UNITED STATES PATENT AND TRADEMARK OFFICE

APPLICATION NO.	FILING DATE	FIRST NAMED INVENTOR	ATTORNEY DOCKET NO.	CONFIRMATION NO.
10/726,767	12/03/2003	Margaret Marie Nixon	AQMED.0103	4214

**Office Action Summary**

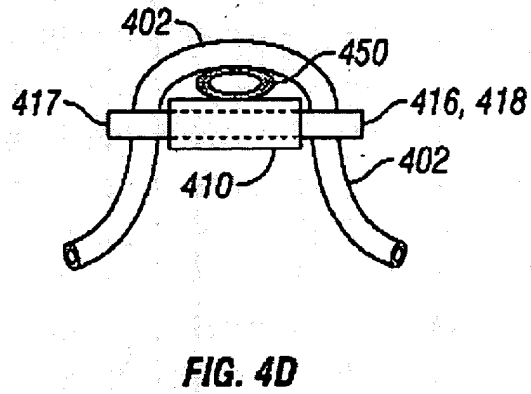
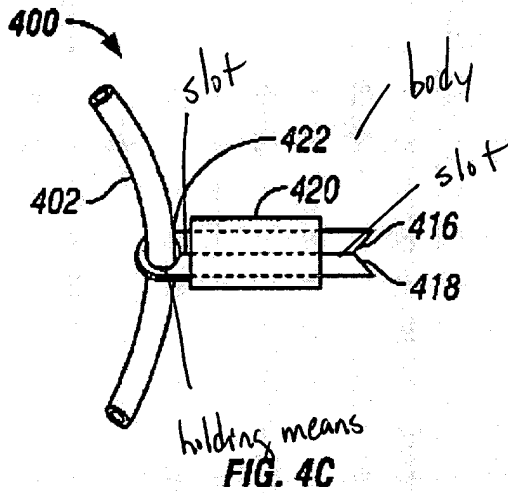
6. Claims 1-13 are rejected under 35 U.S.C. 102(b) as being anticipated by Smith 4140125.

7. Smith teaches a tensioner for surgical tape, the tensioner comprising: a unitary tensioner body, the tensioner body having attaching means; holding means; wherein the tensioner is formed of plastic; the attaching means comprises an elongated slot through the unitary tensioner body; the holding means comprises a circular opening through the unitary tensioner body; the holding means comprises an elongated slot through the unitary tensioner body (see figs. 4C and 4D of 4140125).

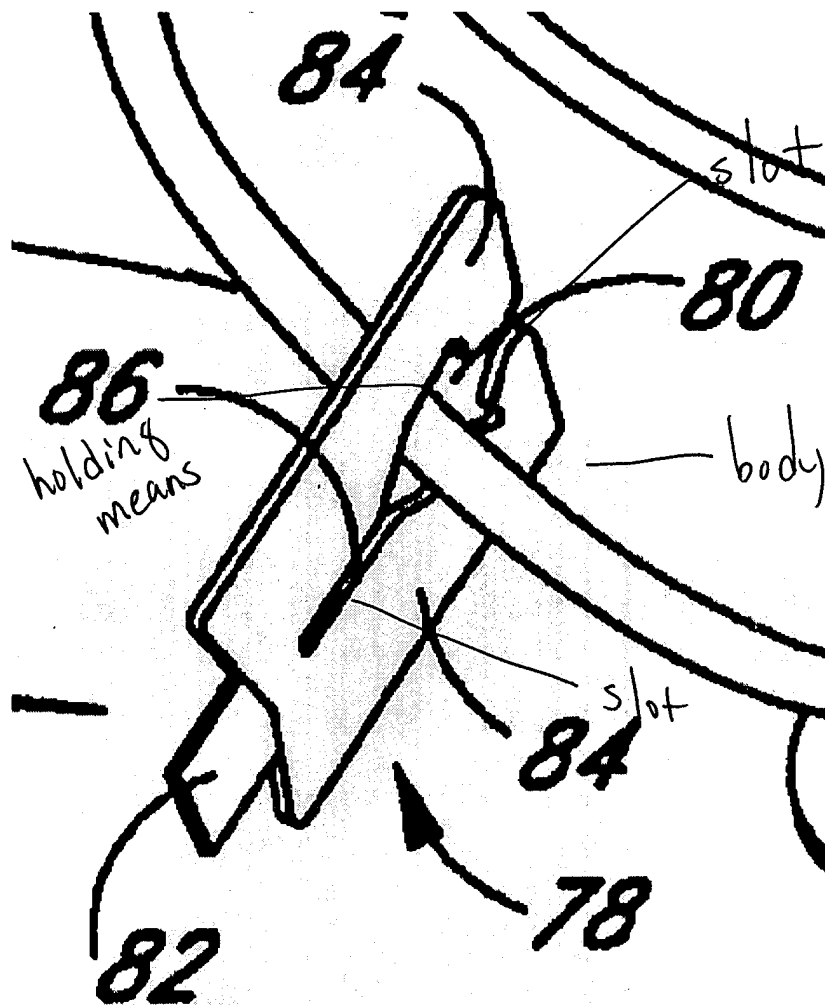
8. Claims 1-3, 5-7, 9, and 10 are rejected under 35 U.S.C. 102(b) as being anticipated by Bierman 5354282.

9. Bierman teaches a tensioner for surgical tape, the tensioner comprising: a unitary tensioner body, the tensioner body having attaching means; holding means; wherein the tensioner is formed of plastic; the attaching means comprises an elongated slot through the unitary tensioner body; the holding means comprises an elongated slot through the unitary tensioner body. (see fig. below).
